FMB130 Product Change Notifications

Product change notifications (PCN) is the way of informing customers of upcoming changes related to Teltonika products. This includes outward appearance adjustments, hardware improvements, firmware changes, changes to package contents, etc. This page stores information regarding changes to the FMB130 tracking device. Below you will find a list of both upcoming and already implemented changes sorted from newest to oldest (top to bottom).

2021.04.30: Bluetooth® Improvement

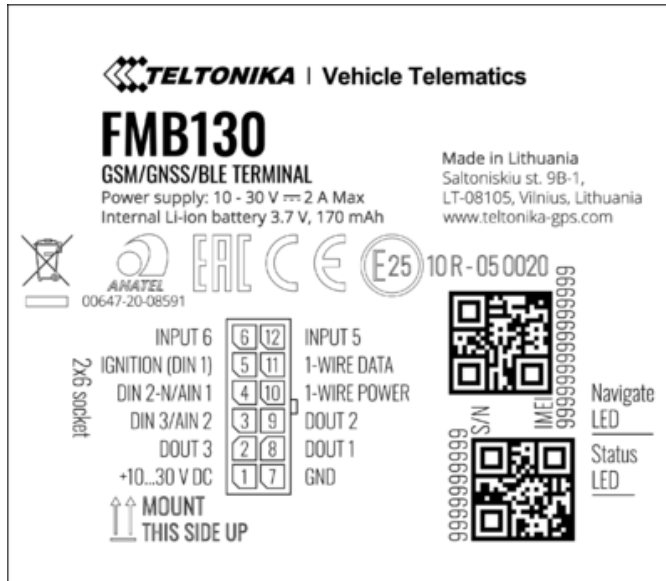
We would like to inform you, that Bluetooth® performance for the FMB130 device will be updated in the factory from October 2021.

Change type Internal
Detailed description Bluetooth® antennas are improved for FMB130 device ensuring better signal strength. The efficiency of Bluetooth® antennas is considerably increased when receiving or transferring data.
Change reasons Following the changes, the capabilities of our devices will be greatly improved to provide better performance when Bluetooth® signal is obstructed or longer distance coverage is required
Product release date October 2021
